Display

Date: **October 23, 2000**

Subject: **LOSS OF WHITE BALANCE**

Model: **OEV-142, OEV-143, OEV-202, OEV-203**
PVM-1353MD, PVM-1450MD, PVM-1453MD
PVM-14M2MDE, PVM-14M2MDU
PVM-1953MD, PVM-2053MD
PVM-20M2MDE, PVM-20M2MDU

Figure 1

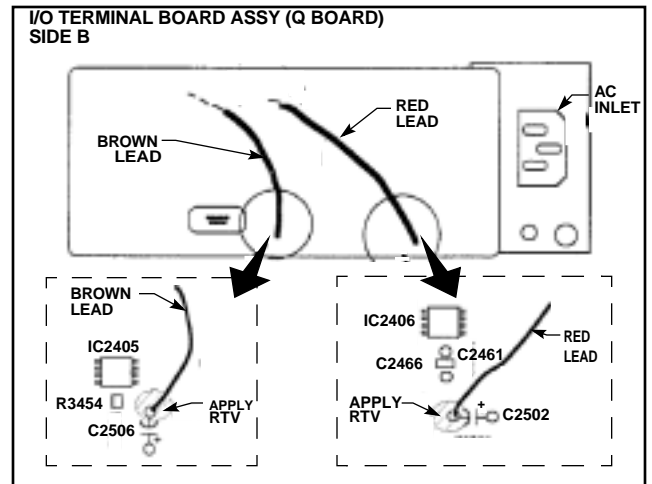
The input/output terminal board may warp when mounted, causing poor contact in the 75Ω termination switch. As a result, the signal level becomes unstable, and white balance is lost.

NOTE: When replacing the former input/output terminal assembly, P/N 1-537-877-11, with the new part, P/N 1-537-877-15, remove the soldered 2-pin connector harness from the former (suffix -11) board and install it on the new (suffix -15) board (side B) as follows and as shown in Figure 1:

1. Solder brown lead of connector harness to negative lead of capacitor C2506.
2. Solder red lead of connector harness to negative lead of capacitor C2502.
3. Apply RTV as shown.
